**Work Order ID 68564**

DRAWING NO. D2580	TITLE 205 SKIDTUBE ASSEMBLY	REV. D	DART AEROSPACE LTD ENGINEERING ORDER		D.E.O. NO. D2580-D-1	SHEET NO. SHEET 1 OF 1	SCALE NTS
DRAWN <i>UP</i>	CHECKED <i>L</i>	MFG. APPR. <i>E</i>	APPROVED <i>MP</i>		DE APPR. <i>MP</i>		
DATE 10.09.22	DATE 10.11.04	DATE 10.11.04	DATE 10/11/04		DATE 10.11.04

**PURPOSE:**

CHANGE ALL WELDED CROSSBOLT SPACERS TO SWAGED SPACERS

**SECTION D-D**  
NOT TO SCALE

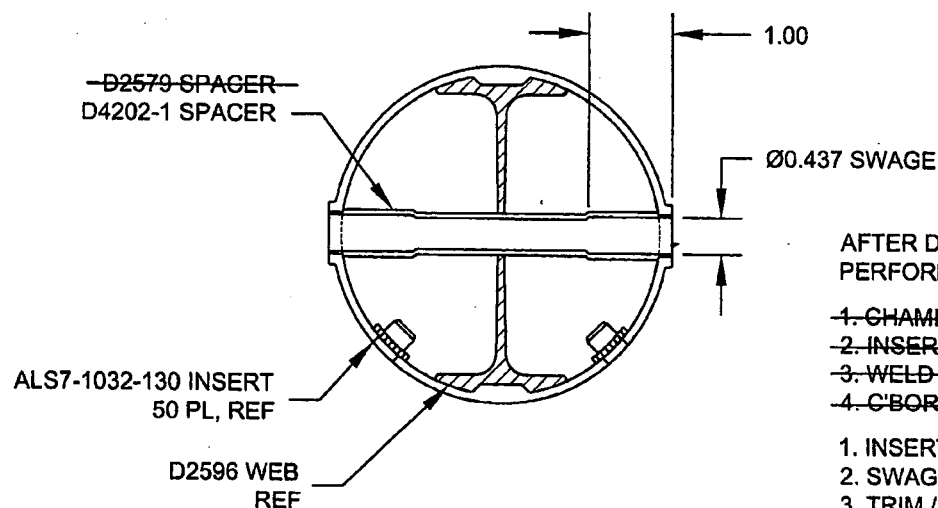
PARTS LIST IS AMENDED AS FOLLOWS:

WAS

QTY	QTY	PART NUMBER	DESCRIPTION
-041	-045		
20	24	D2579	CROSS BOLT SPACER

SECTION D-D & SECTION H-H ARE AMENDED AS FOLLOWS:

AFTER DRILLING AND BENDING ASSEMBLY  
PERFORM THE FOLLOWING FOR Ø0.508 HOLES ONLY:

1. CHAMFER HOLE 0.050 X 45°
2. INSERT D2579 SPACER (20 PLACES)
3. WELD INTO PLACE AND GRIND FLUSH
4. C-BORE D2579 SPACER TO Ø0.437 X 1.00 DEEP

IS

20	24	D4202-1	SPACER
----	----	---------	--------

1. INSERT D4202-1 SPACER, 20 PL (-041) OR 24 PL (-045)
2. SWAGE TO Ø0.437 X 1.00 DEEP PER QSI 002
3. TRIM / GRIND FLUSH PER QSI 002
